# Comments on Outer Permutation Size

Document Number: IEEE C802.16m-08/511r1

Re: IEEE 802.16m-08/016 – Call for Comments on C802.16mDL\_PHY-08/046 “802.16m DL PHY Structure Baseline Content Suitable for use in the 802.16m SDD”

# Channelization Procedure

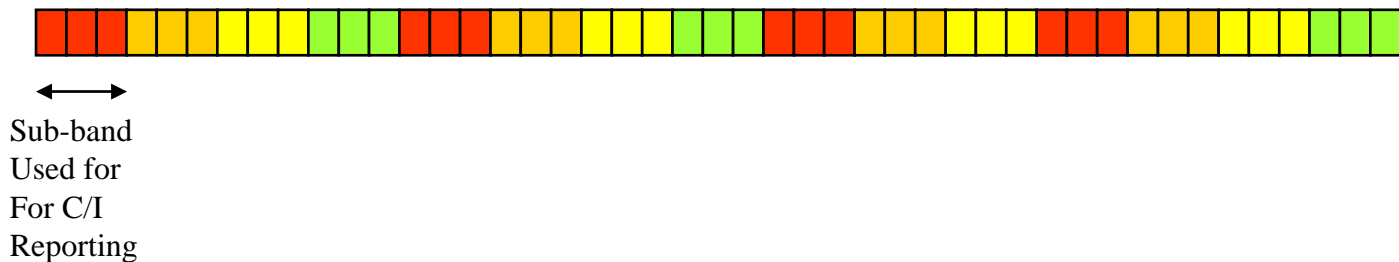
- In C802.16mDL\_PHY-08/046 and as described in C80216m-08/009r5, the proposed text indicates that the outer permutation should be performed in the units of PRUs

- Outer permutation spreads the PRUs of each frequency partition evenly across the band as shown in the figure below. The localized resource units (LLRU) will be evenly spread over the entire band even for the case where there is no distributed resource with the frequency partition.

- For example, if there are 4 FFR zones then each FFR zone contains PRUs that are spaced by 4 PRUs.
- For frequency selective scheduling, the mobiles report multiple C/I. In order to reduce MS complexity, the mobiles should be calculating a C/I based on a sub-band rather than per PRU.

- With this outer permutation, when there are 4 FFR zones the number of PRUs in a sub-band is one. This results in only one assigned LLRU per user per sub-band, which increases the signaling overhead.

- The outer permutation should be performed in the units of N PRUs
- In this case, there will be N contiguous LLRUs and the contiguous blocks of LLRUs from each FFR zone are evenly spread over the entire band.
- When there are 4 FFR zones there are multiple PRUs in a sub-band.
- Each assigned user can be assigned multiple PRUs, which will reduce the signaling overhead.
- Even when a FFR zone is divided into LLRU and DRU, for example,  $\frac{2}{3}$  of resource is allocated for LLRU and  $\frac{1}{3}$  of resource is allocated for DRU, there will be 2 contiguous LLRU in one sub-band. At the same time, each DRU has 4-order diversity which already saturates the diversity gain.

- Section 11.5.2.2 Downlink Subcarrier to Resource Unit Mapping
  - Delete line 27
  - Add the following text.
    - “1. First-level or outer permutation is applied to the PRUs in the units of  $N \times \text{PRU}$ , where  $N$  is configured by the BS.”
